City of Richmond Planning and Development Department

To:	Planning Committee	Date:	June 15, 2011
From:	Brian J. Jackson, MCIP Director of Development	File:	RZ 08-423207
Re:	Application by Home Run Develop at 8540 Alexandra Road from "Auto

Staff Report

Attachment 5: Dedications and Right-of-Way Scheme

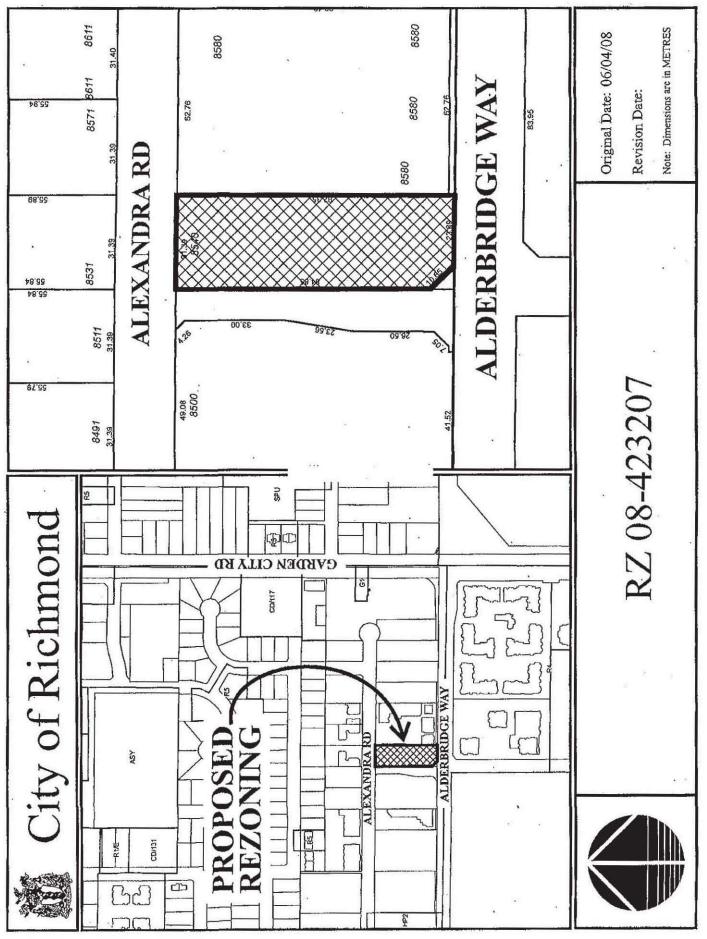
- Specific required land dedication and Public Rights of Passage Rights-of-Way (PROP ROW) include:
 - a. 3.15 m wide dedication along the west PL (i.e., Kwantlen Street frontage). This includes following the ultimate curb and gutter at both intersections).

- b. 3.4 m wide dedication along the south PL (i.e., Alderbridge Way frontage).
 - c. 3.0 m wide PROP ROW along the new west PL to accommodate proposed layby, tree boulevard and sidewalk, including a 4 m x 5 m corner cut on the northwest (Kwantlen/Alderbridge Way) and southwest (Kwantlen Street/Alexandra Road) corners. Note that the 4 m is the offset distance measured from the Kwantlen ROW line while the 5 m is the offset distance measured from Alexandra Road property line and from Alderbridge Way new property line.

- d. A volumetric PROP ROW is required along the Kwantlen Street frontage behind the line of the ROW to ensure adequate horizontal and vertical clearance is provided. The width of the volumetric PROP ROW would range between 3.65 m (where the layby is) and 0.5 m (where there is no layby), measured from the SROW along the new west property line. The height of the volumetric PROP ROW would range between 3.0 m (to ensure adequate height for pedestrians) and 5.4 m (to ensure adequate height for vehicles, including min. 0.9 m offset from the face of the curb).

- e. An additional 3.16 m wide PROP ROW required for the greenway and sidewalk along Alderbridge Way.
- All required road dedications and SROW's required for this project are shown on the attached sketch (Attachment 5) and must be confirmed as accurate and complete via a survey plan to be submitted for approval by Transportation Engineering prior to adoption of the rezoning.
